**No.: 05 TS – 05Rev**  
February 9, 2006

SUBJECT: **MBE900 Frozen Breather Tubes**

Figure 1 - Frozen Breather Tube

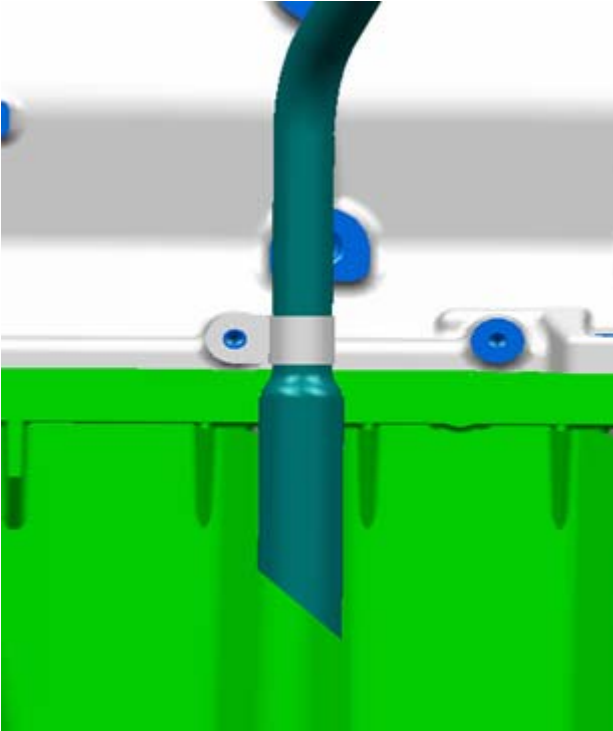
- The end of the breather tube can potentially freeze on MBE900 engines under extremely cold operating conditions.
- The breather tube is currently routed along the right side, near the front of the engine and down past the oil pan rail close to the bottom of the oil pan (see Figure 1).

- Replace the breather tube with the improved design.
- The new design incorporates a larger diameter at the end of the tube, slightly shorter length, and a 45-degree angle cut at the end of the tube (see Figure 2).
- These changes will help keep the tube warmer and reduce the chance of snow and slush from the roadway coming in contact with the tube and subsequently freezing.
- The new tube became effective with engine serial number 90291900526389 built on October 19, 2005.
